SUBJECT: VICTORY CENTER TMP SUP #2016-0039

**Development Site Plan #2016-0018  
 Transportation Management Plan SUP #2016-0039  
 5001 Eisenhower Avenue – Victory Center Amendment**

**Development Site Plan #2016-0018  
Transportation Management Plan  
SUP #2016-0039  
5001 Eisenhower Avenue - Victory Center**

Figure 3a – Alternate A: Full Streetfront Build

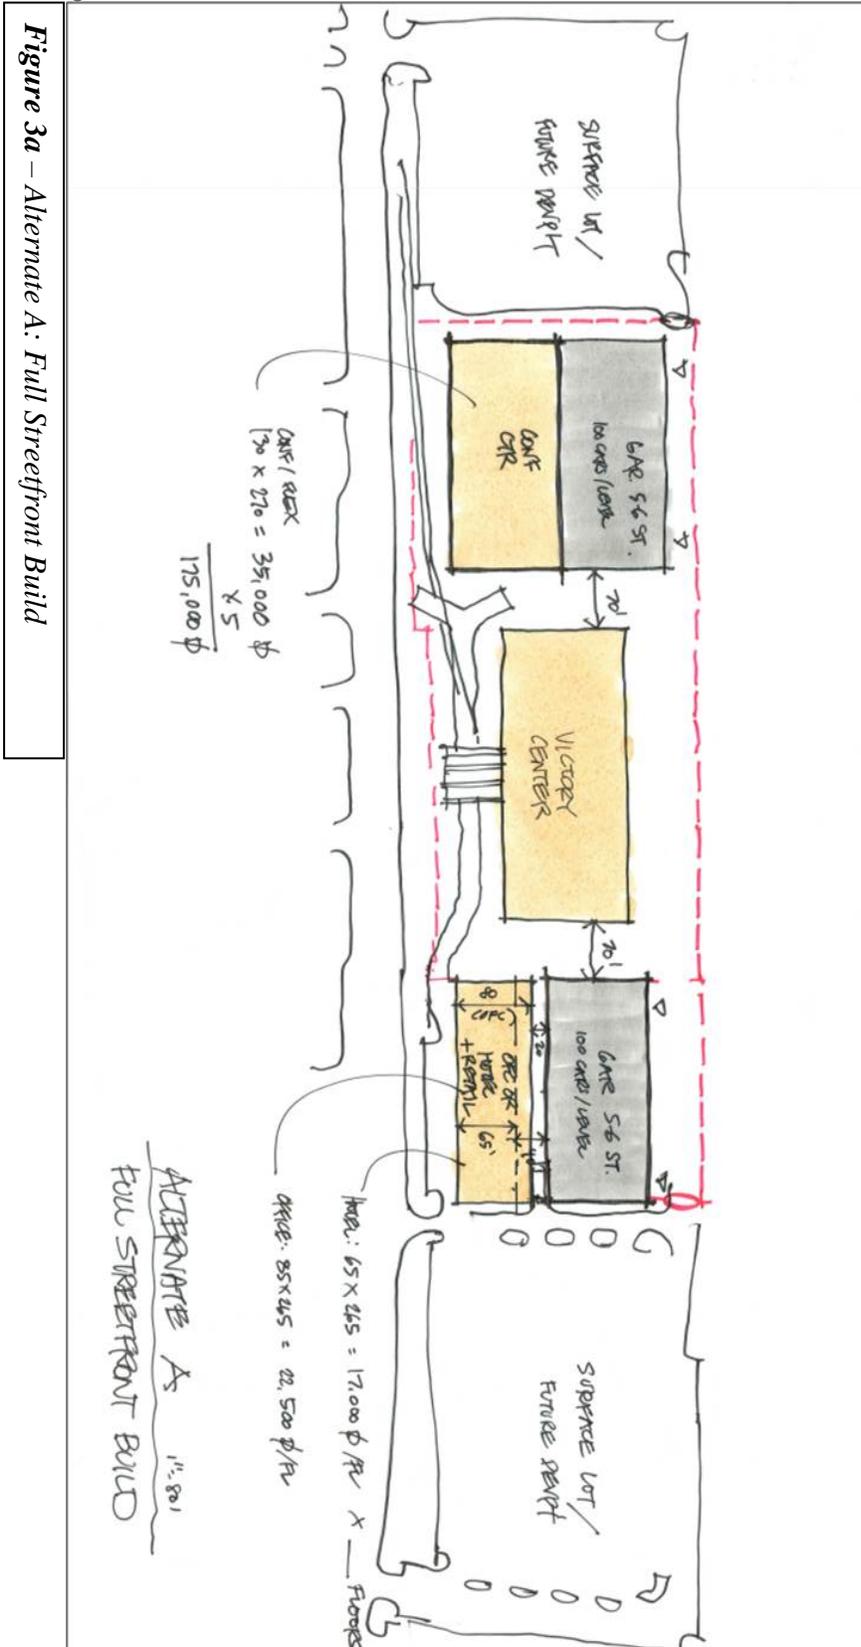
The Plan calls for active uses to be located on all street frontages, which is not feasible given the security requirements of the Federal tenants being sought. Previous approvals have always called for, and allowed, above ground parking structures at this site. DSP#2004-0037 allowed up to three parking structures; DSP#2010-0011 allowed two structures at 62' each. The current proposal has one structure, which will be limited to maximum height of 70'. Staff has also provided alternative building proposals, that would also help to minimize these effects, as shown in the graphics (Figures 3a and 3b) at the end of the report, and discussed in the staff analysis.

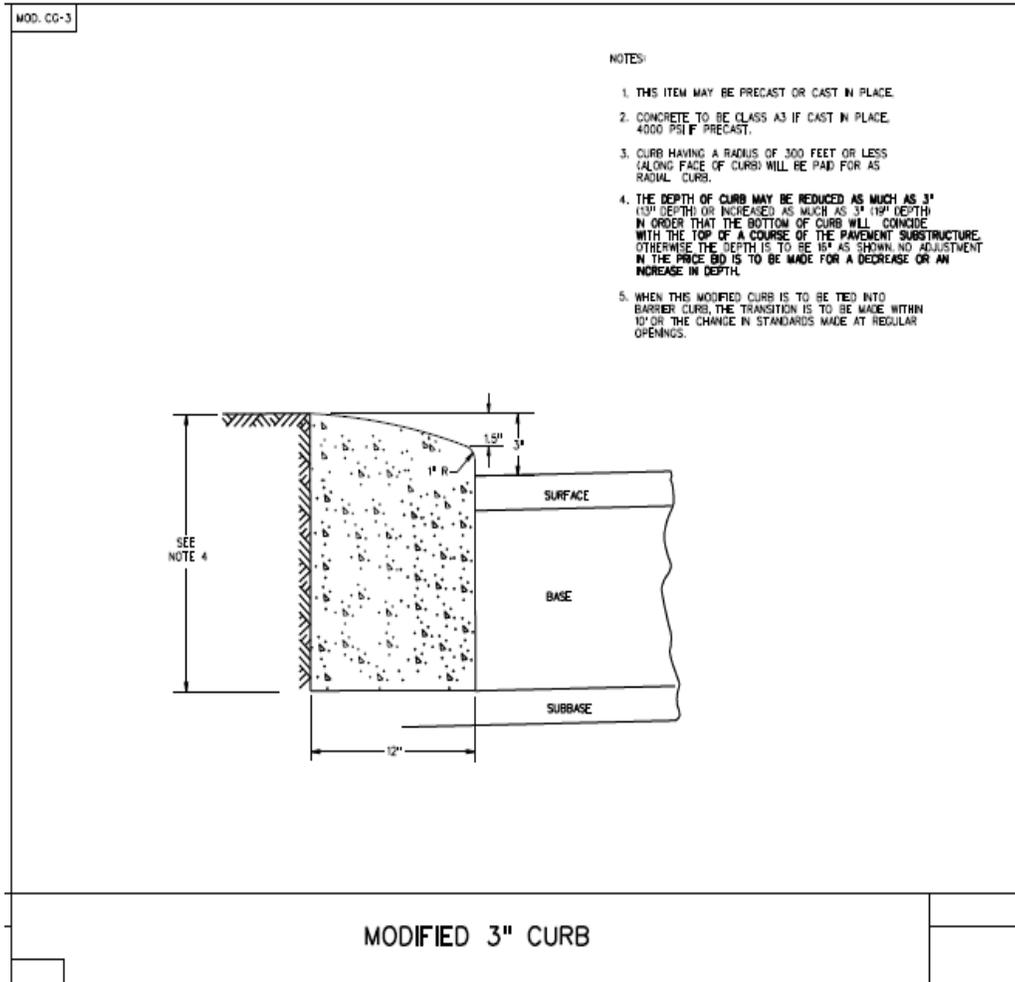
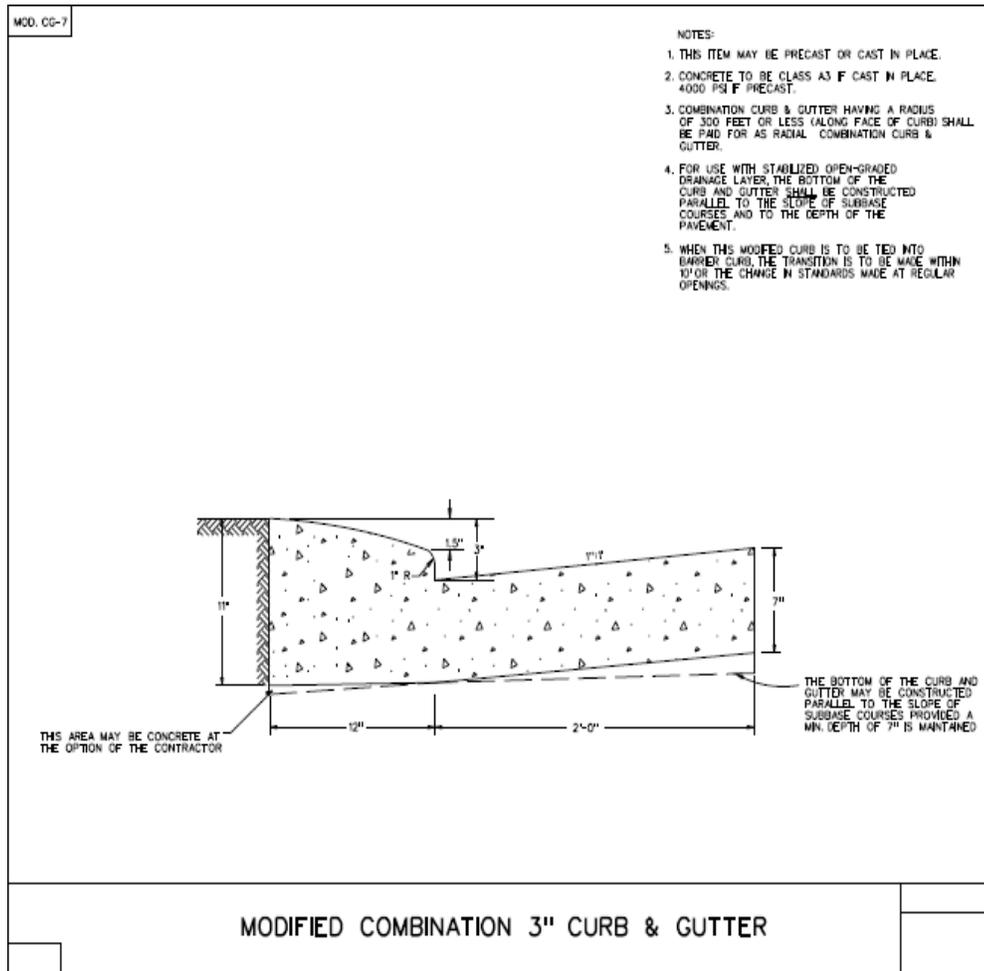
C-7 **CODE REQUIREMENT ADDED BY STAFF** The fire service plan shall show placement of emergency vehicle easement signs. See sign detail and placement requirements are as follows:

Emergency vehicle easements shall be a minimum of 22 feet across the travel lane. The emergency vehicle easement shall provide access to strategic areas of the building and fire protection systems. Curbing and street components shall

Tower 203 Turning Specifications

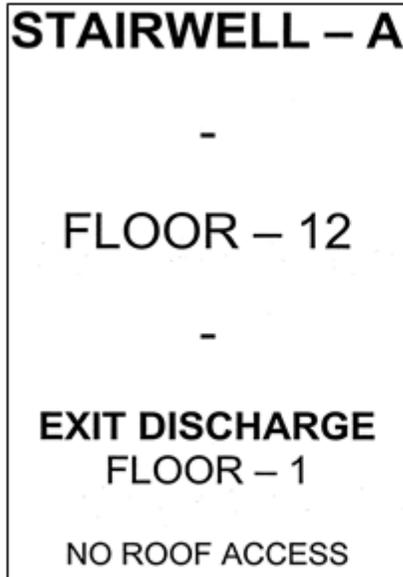
C-8 **CODE REQUIREMENT ADDED BY STAFF** Show fire apparatus vehicle turning radius for all roadways based on the following specifications:

- Turning Radius – Wall to Wall = 54.98 feet + / - 2 feet
- Curb to Curb = 51.33 feet + / - 2 feet
- Inside turning radius = 37.73 feet + / - 2 feet
- Overall Length – 47' – 4 ½"
- Overall Width – 98"
- Wheel Bases from front axle to both rear axles – 240"
- Tandem axle spacing – 56" CL of axle to CL of axle
- Gross Weight – As built with no equipment or water gross weight = 66,000 lbs
- Angle of Approach – 13 Degrees
- Angle of Departure – 11 degrees
- Ramp Break Over – Break over angle is 9°

Ex. Stairway Identification Sign

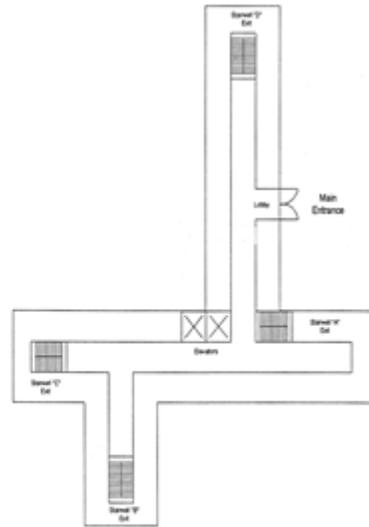
C-9 **CODE REQUIREMENT ADDED BY STAFF** Provide Stairway Identification. Stairway identification signs shall be provided at each landing in all interior exit stairways connecting more than three stories. Stairways shall be identified by letter designation starting next to the main entrance with "A" and continuing in a clockwise or left to right pattern using consecutive letters of the alphabet for each additional stairway. Two copies of the stairway signs shall be submitted to the fire official for approval before occupancy.

exterior and the general layout of the lobby of the first floor. Stairways shall be denoted by letter as required.
